DFCM Addendum #3

Reference: Bastian Equestrian Arena
DFCM Project #25401770
U3P Event #CS25039-Stage II

ADDENDUM NO. 1
April 14, 2025

USU Bastian Equestrian Arena

sheet:
A213
PERMIT SET

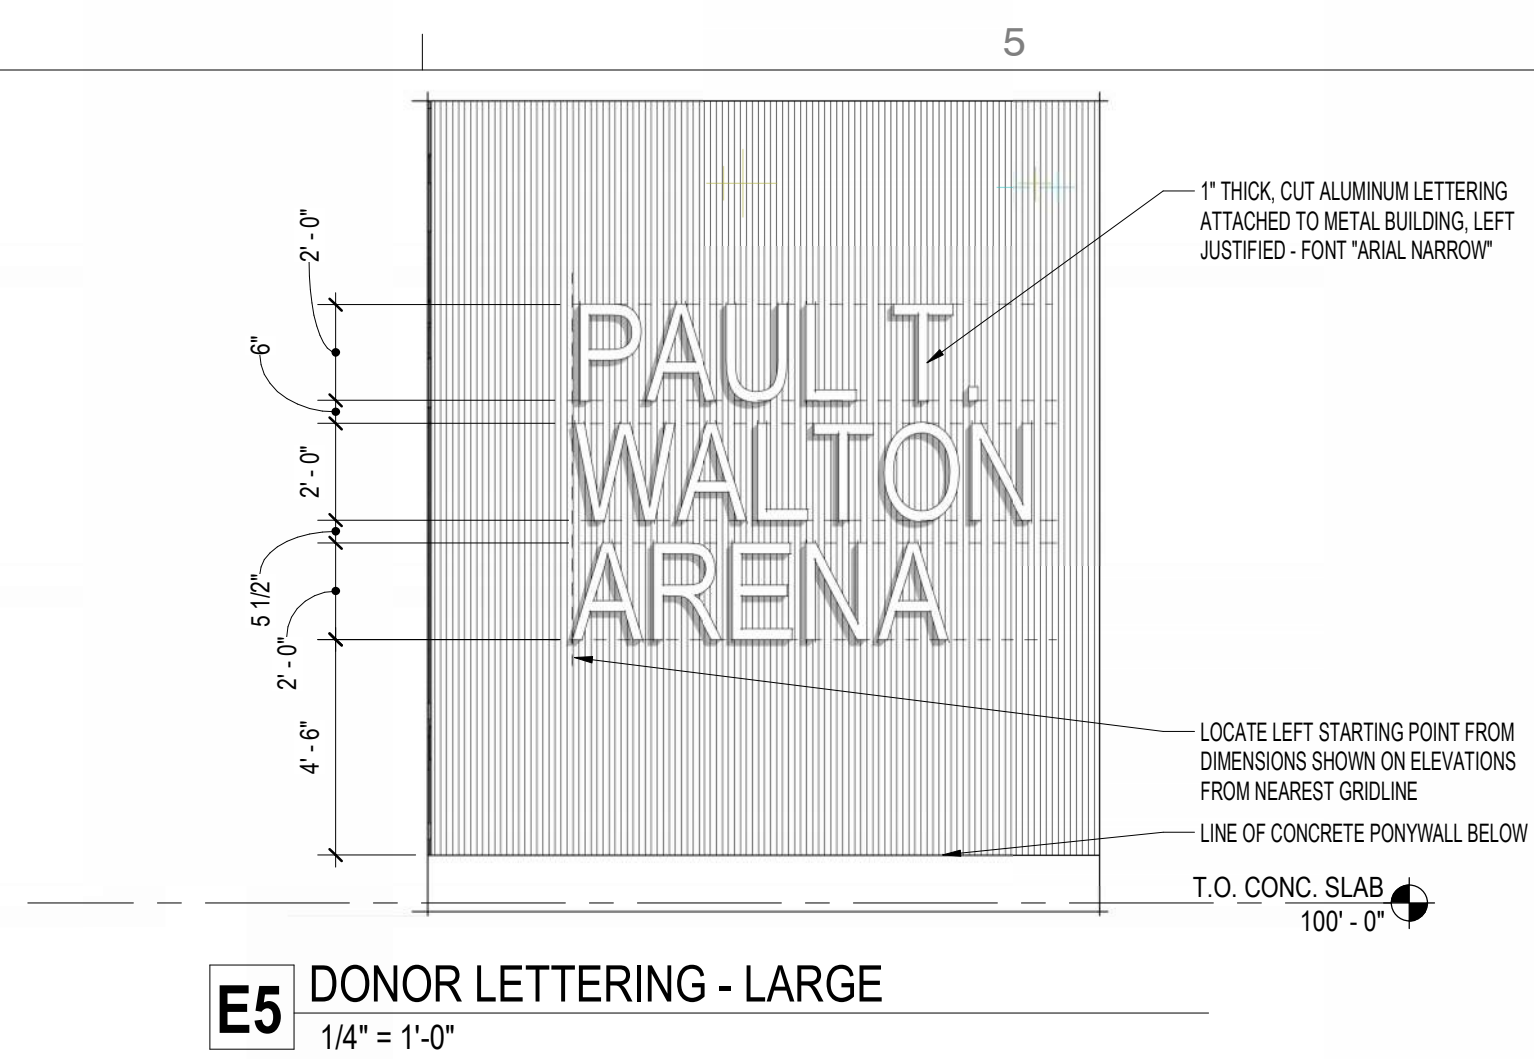
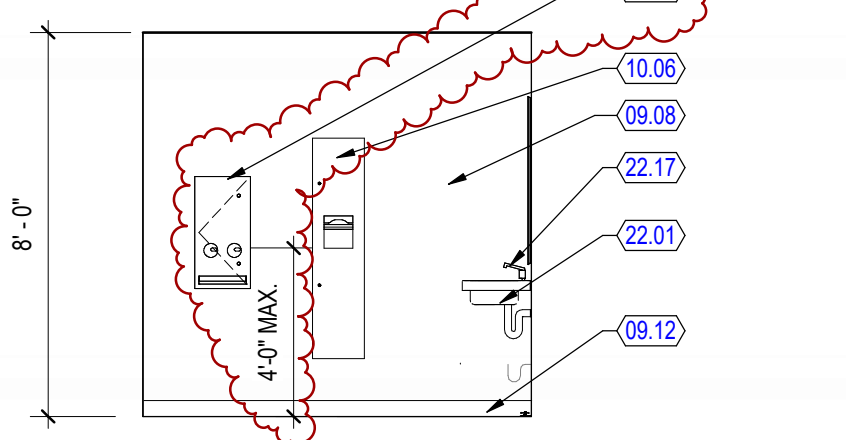
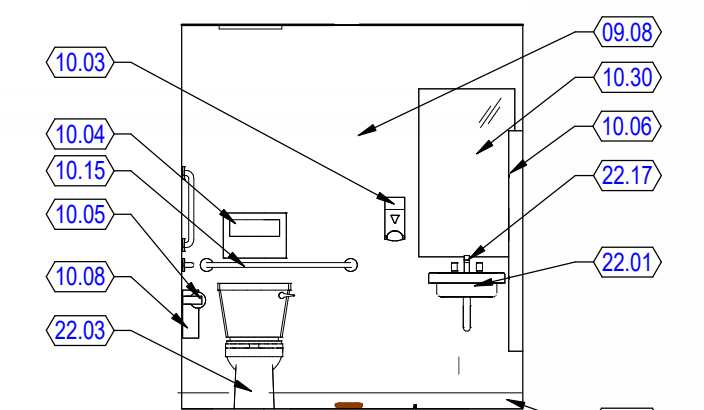
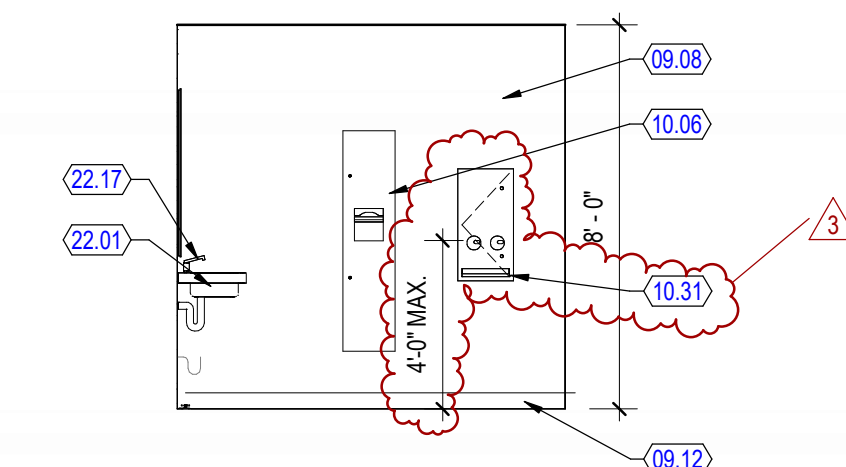
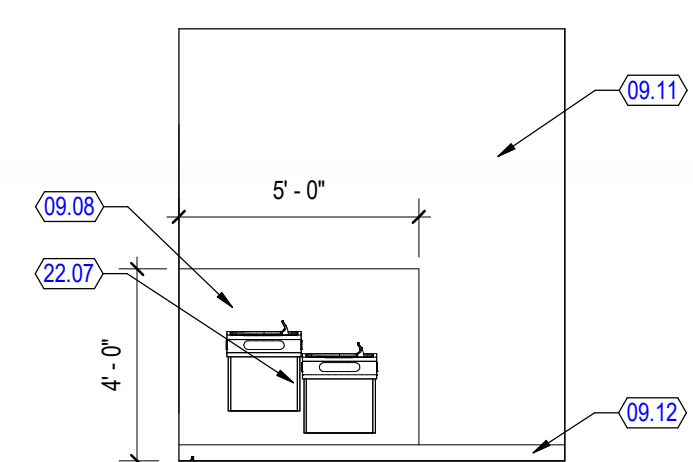
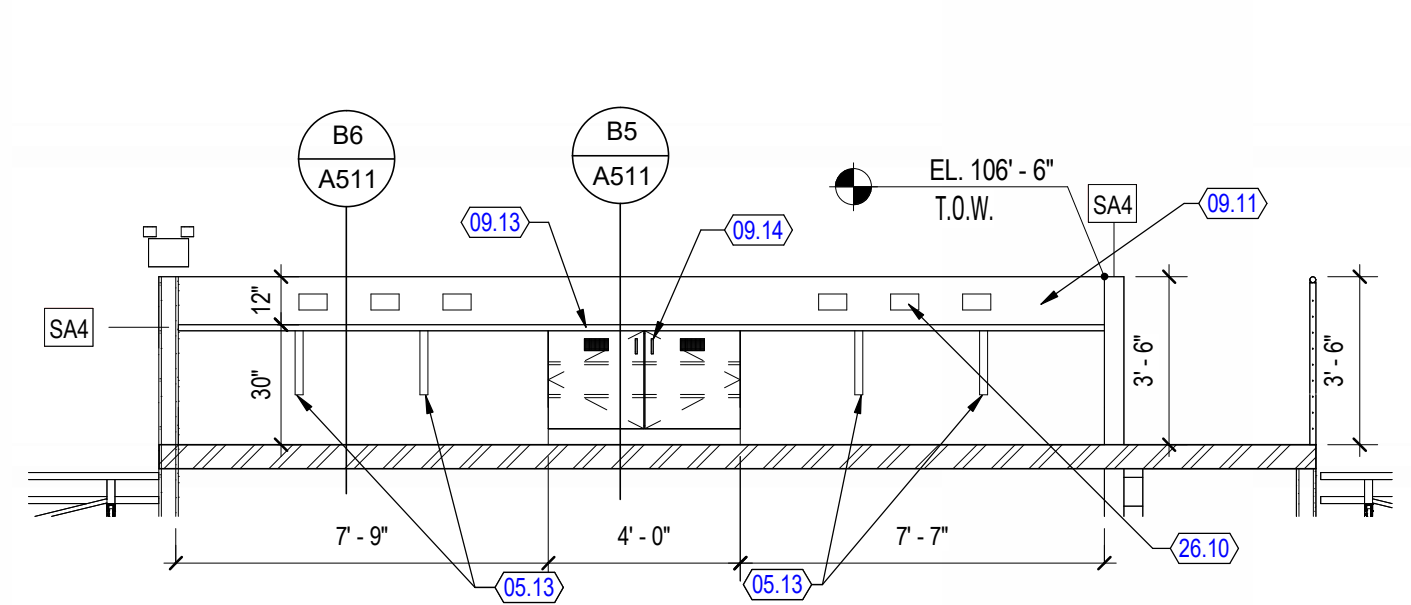
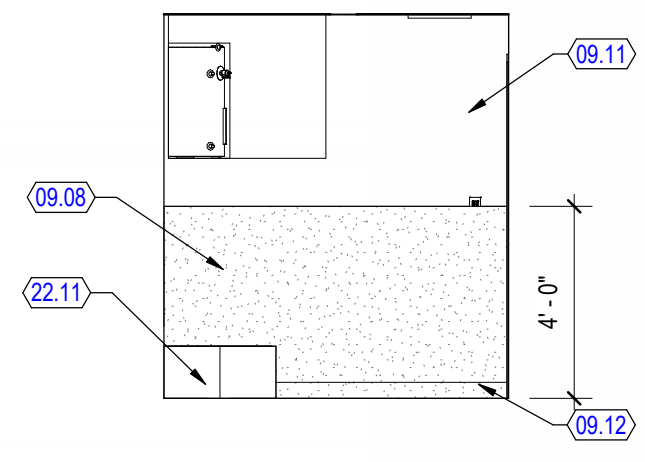
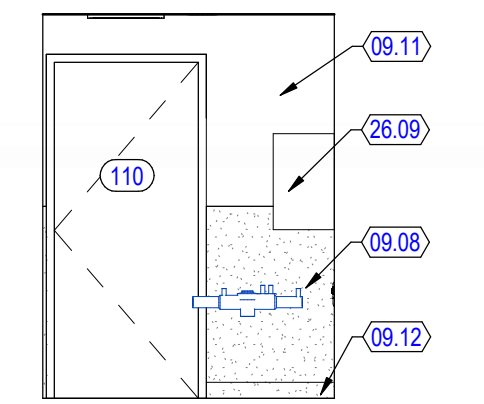
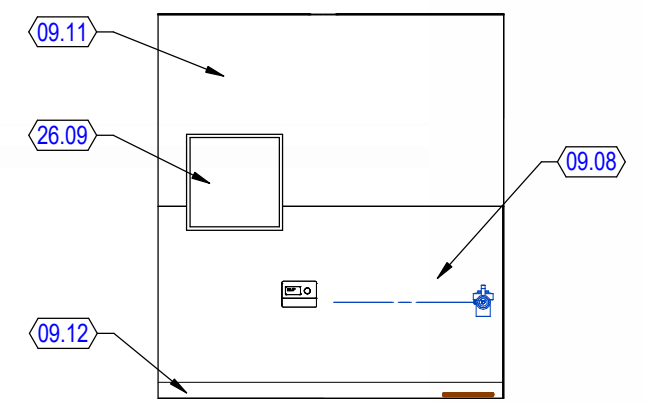
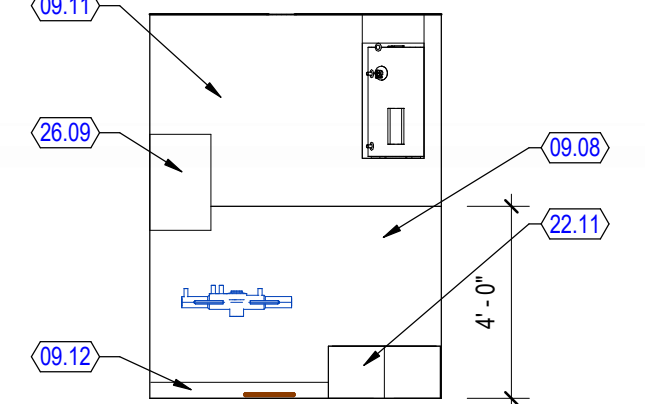
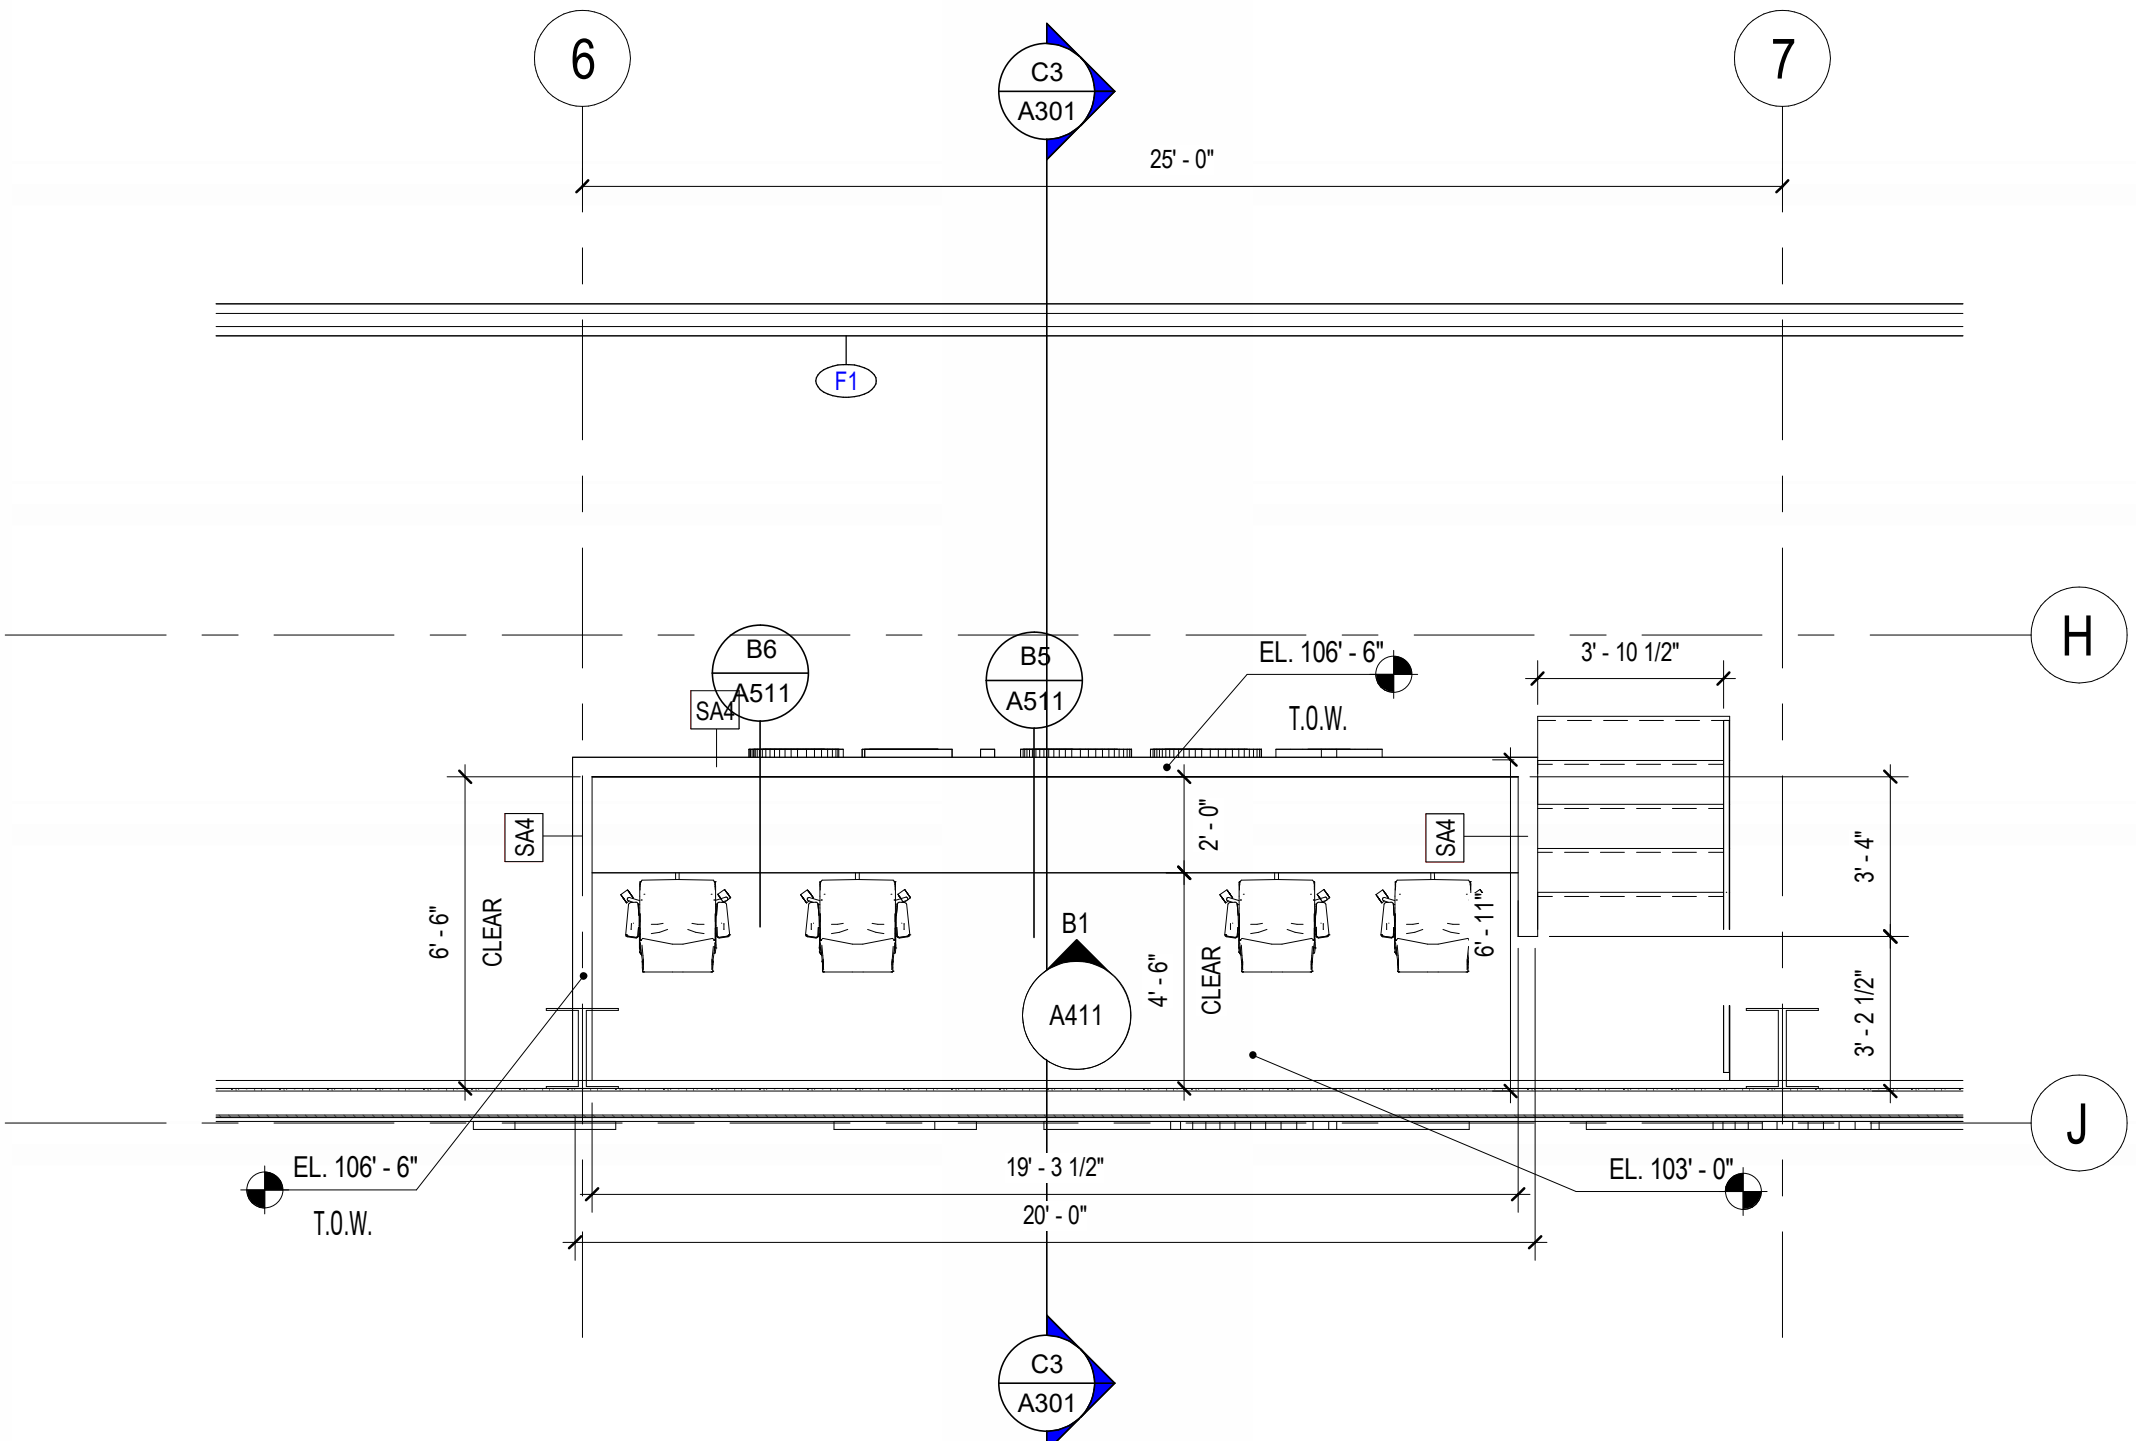
Question 008 - A411 – Note: USU typically provides a sanitary napkin vending station. If it is provided, where will it be mounted in the toilet rooms?

Question 024 - Tie Rail – keynote 05.09 indicates detail on elevation. Please provide detail as no detail is shown on elevation.

Response: A sanitary napkin vending station has been added to the restroom elevations and the accessory schedule. See sheets A411 and A601.

Response: A new detail has been added to the drawings for this tie rail ON C4/A511 and called out on the interior elevations for the arena on sheet A213. See clouded drawings.
